Technical Note

Bartons Road, Havant

24-097-006 Rev A

Transport Assessment Addendum

Figure 2.1: Existing Phase and Stage Sequence Diagram

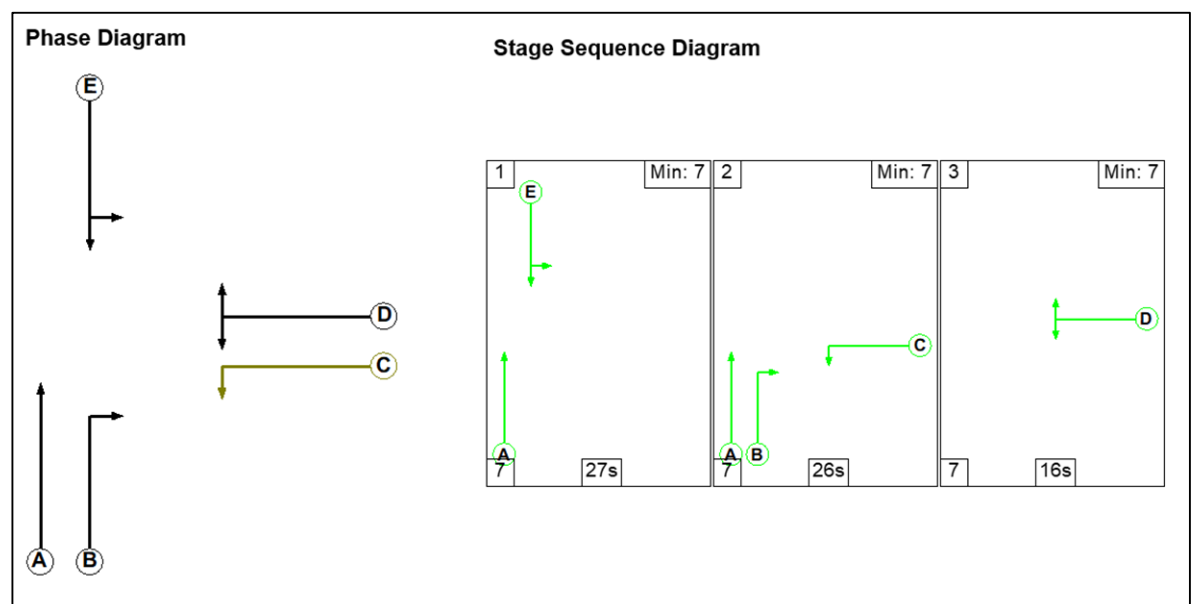
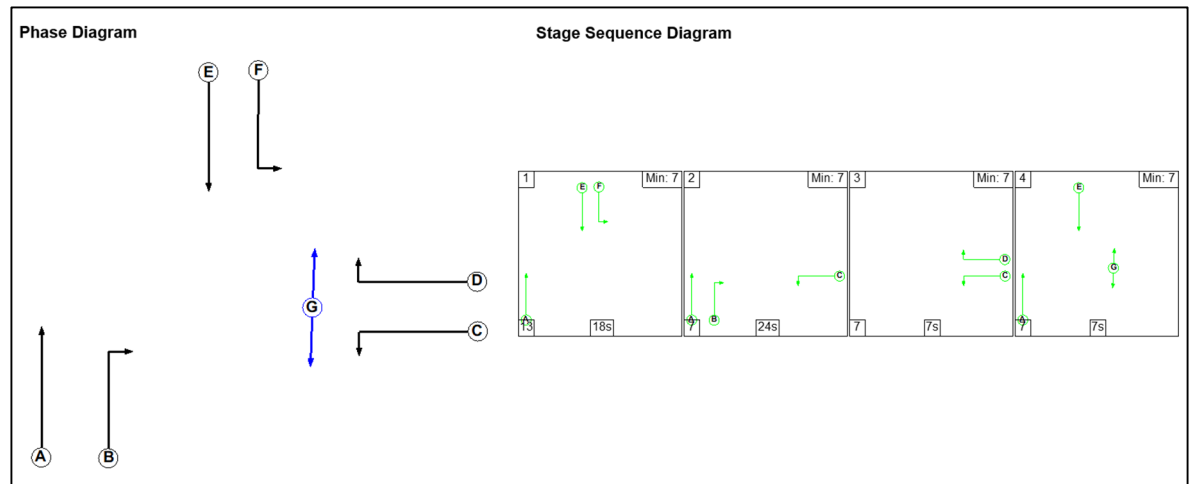
In order for the Highway Authority to undertake a full review of this junction assessment work the modelling files should be shared directly with the Highway Authority. From an initial view it is apparent that the phases for the toucan have not been included in the signal timings and therefore the modelling results are not presenting a correct assessment of the junctions operation. It has previously been agreed that the pedestrian/cycle crossing demand is called every other cycle and this remains a robust assumption.

- 2.7.9 For 2030 Do Minimum scenario, the junction will operate within capacity with a maximum DoS of 75% in AM peak and queue of 11 pcu. Similarly, in the PM peak maximum DoS is 84.4% and a maximum queue of 14 pcu.
- 2.7.10 As mentioned above, the proposed development would improve the junction staging to include a dedicated stage for cyclists.
- 2.7.11 The proposed improvement introduces an additional signal phase for the Petersfield Road northbound approach, allowing the left-turn movement to operate independently from the ahead movement. This separation facilitates the incorporation of the Sparrow crossing into the overall signal configuration. For reference, the existing and proposed staging and phasing arrangement is shown in figures below.

2.7.12 Accordingly, the LinSig model has been updated to reflect these proposed changes as summarised below.

Figure 2.4: Total Committed Developments Flows - AM

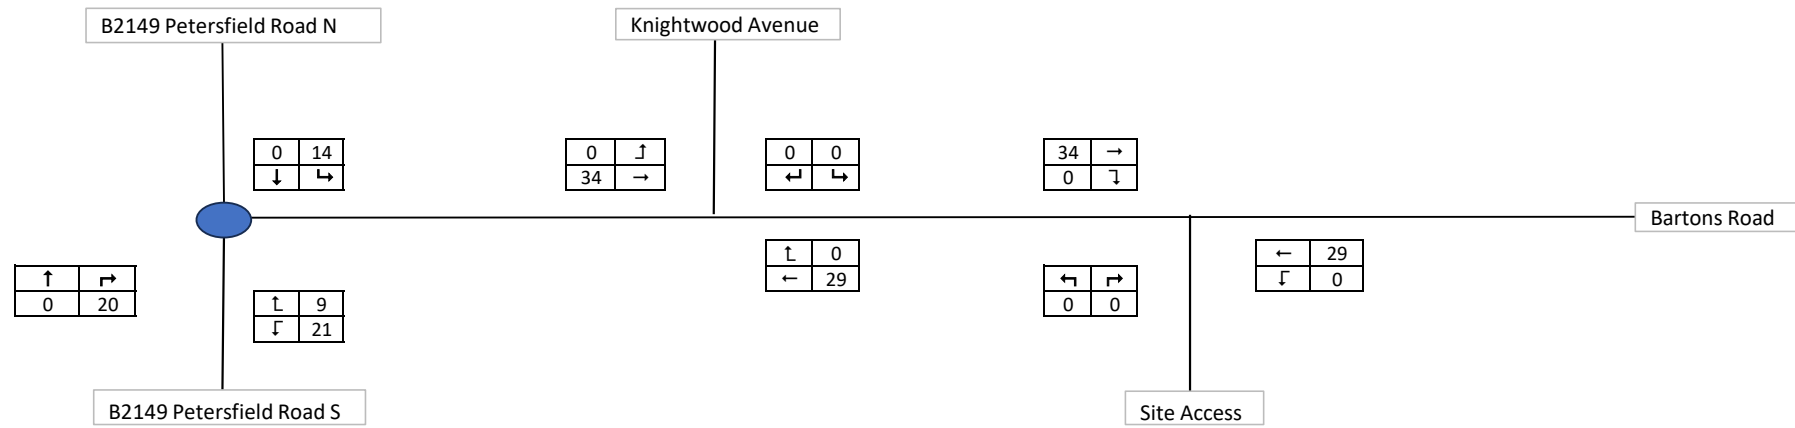
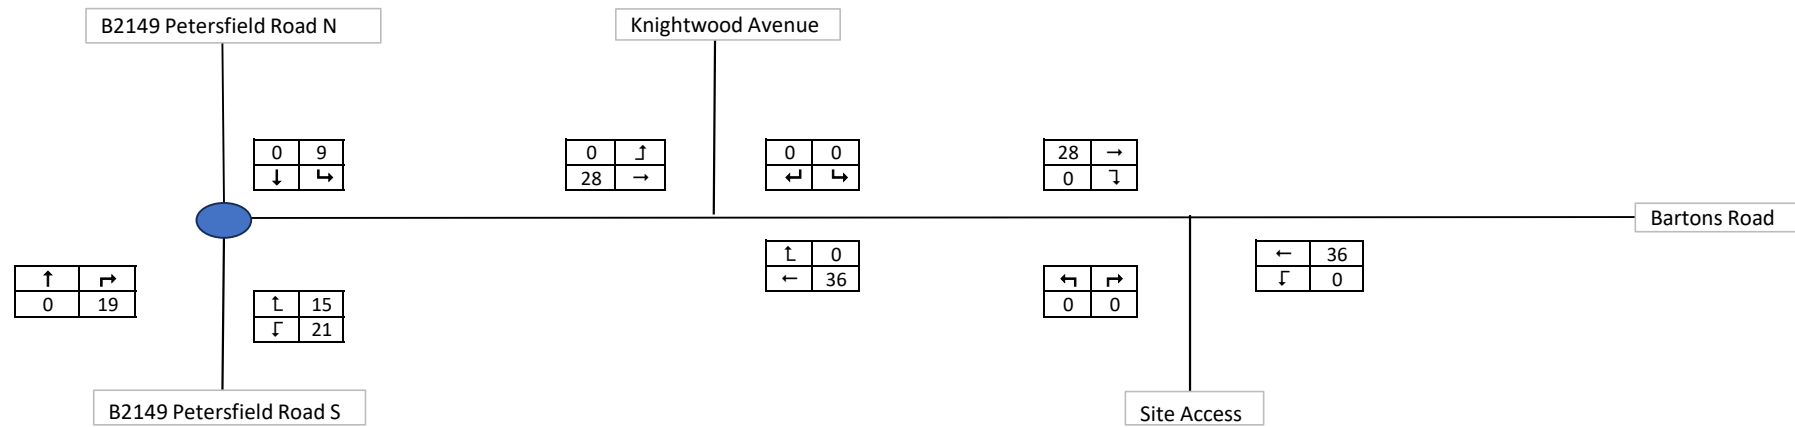
Traffic surveys were undertaken in June 2025 covering each peak period including at the junction of Petersfield Road/Bartons Road. The survey data was utilised to form a baseline for traffic modelling with committed developments added as per the pre-application advice and TEMPRO background growth assumptions. The survey data has not been provided within the TA and should be included for assessment of the junction modelling and consideration of the junction form.

- 2.6.14 This application was for the redevelopment of an existing trip generating use. Chapter 6 of the Downley Road TA, prepared by SLR, compares the existing trip generation with the proposed site trip generation. Paragraph 6.6 identifies that the development would result in an overall reduction in trips compared to the current site use so similarly, this site has not been considered further within the assessment.
- 2.6.15 The total committed development trips accounted for within our assessment are shown in **Figure 2.4**.
